| Office Action Summary | Application No. 10/082,492 | Applicant(s) SAMSON ET AL. | |

DETAILED ACTION

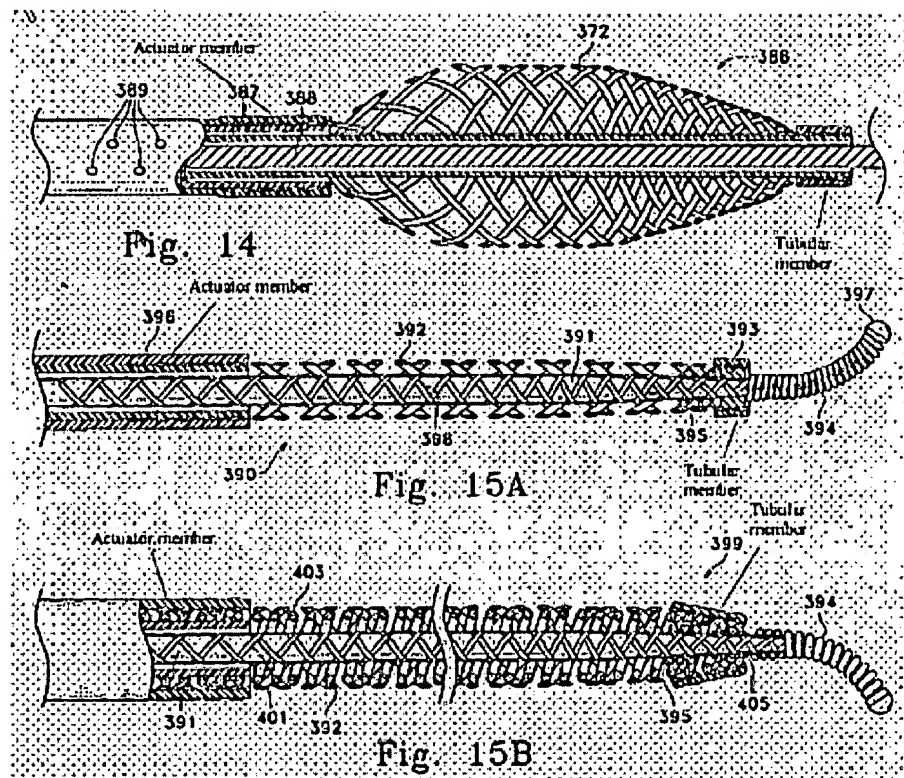
Engelson et al. disclose a device comprising a core wire, e.g. 388 01- 391 with a coil tip coupled to a distal end of the core wire (see for example Figures 14, 15A, 15B). The device further comprises a cage, e.g. 372 or 392. The cage has a distal end, proximal end, first deployment shape, and a second expanded shape. The first and second shapes are different from each other. The device further has a tubular member (see Figures 14, 15A, and 15B) coupled to a distal end of the cage assembly and the tubular member surrounds a distal portion of the core wire proximal to the coil tip.

The device also has an actuator member, as shown above, that has a first position and a second position, and is located proximally to the cage and substantially coaxial about the core wire. When the actuator member is in a first position the cage is in a deployment shape and when the actuator member is in the other position, the cage is in the second expanded shape. The core wire is freely moveably axially through the cage assembly (see col.13, lines 43-44). The tubular member can be considered a bushing. The device can further include an inner coil, e.g. 401, surrounding the core wire within the cage assembly. The inner coil inner coil does not pass distally on the core wire. Engelson et al. disclose the claimed invention except for a cage assembly including a proximal cage and a distal cage.

Engelson discloses the claimed invention except for the use of a proximal and distal cage. Ginsburg discloses the use of a proximal and distal element (balloon) in order to remove the thrombotic material without surgical intervention (Col. 7, lines 12-15). It would have been obvious to one skilled in the art at the time the invention was made to construct the device in Engelson with a proximal and distal cage in view of Ginsburg, in order to have a less extensive procedure.

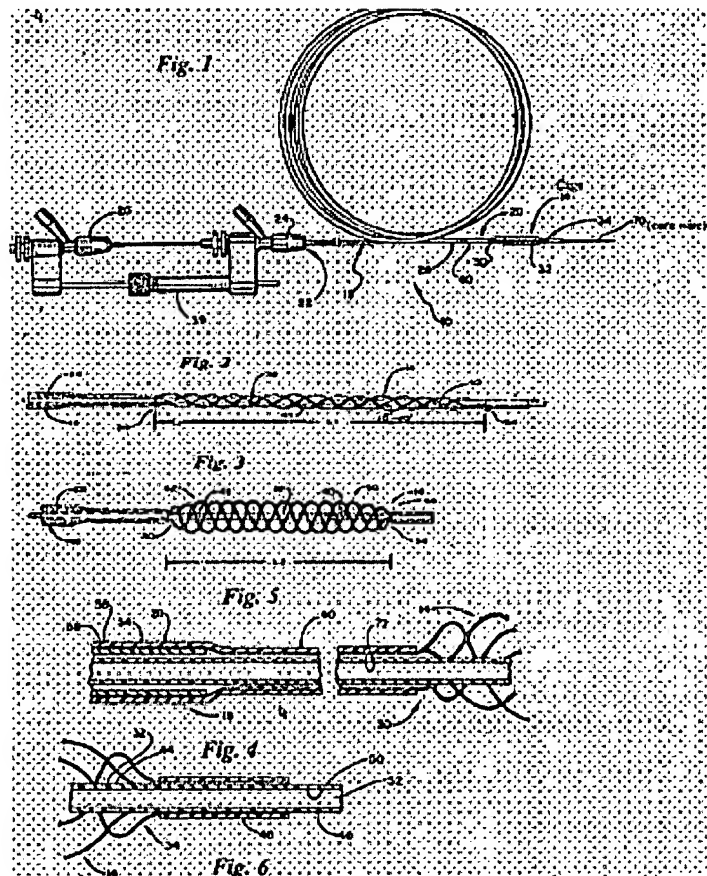
Schmaltz et al. disclose a device comprising a core wire or guidewire 70, a cage 14, a tubular member 46, and an actuator element 18 (see Figures 1-5 below). The cage 14 has a distal end, proximal end, first deployment shape, and second expanded shape, wherein the shapes are different from each other (see Figures 2 and 3 below). The tubular member 46 is coupled to the distal end of the cage assembly and it would surround a distal portion of the core wire or guide wire (see Figures 1 and 6 below). The actuator element has first and second positions and it is located proximal to the cage and it is substantially coaxial about the core wire (see Figure 1). The core wire or guide wire is freely movable axially through the cage (see col. 8, lines 30-35). The core wire or guidewire may be a standard guidewire. The tubular member is considered a bushing and is made of a thermoplastic material, e.g. polyolefin (see col. 7, lines 15-17). The device further includes inner coils or bands, e.g. 40 and 41, made from radiopaque

materials (see col. 6, lines 32-34 and 59-64). The inner coils or bands do not pass distally on the core wire.

Schmaltz et al. disclose the claimed invention except for a cage assembly including a proximal cage and a distal cage. Ginsburg discloses the use of a proximal and distal element (balloon) in order to remove the thrombotic material without surgical intervention (Col. 7, lines 12-15). It would have been obvious to one skilled in the art at the time the invention was made to construct the device in Schmaltz et al. with a proximal and distal cage in view of Ginsburg, in order to have a less extensive procedure.
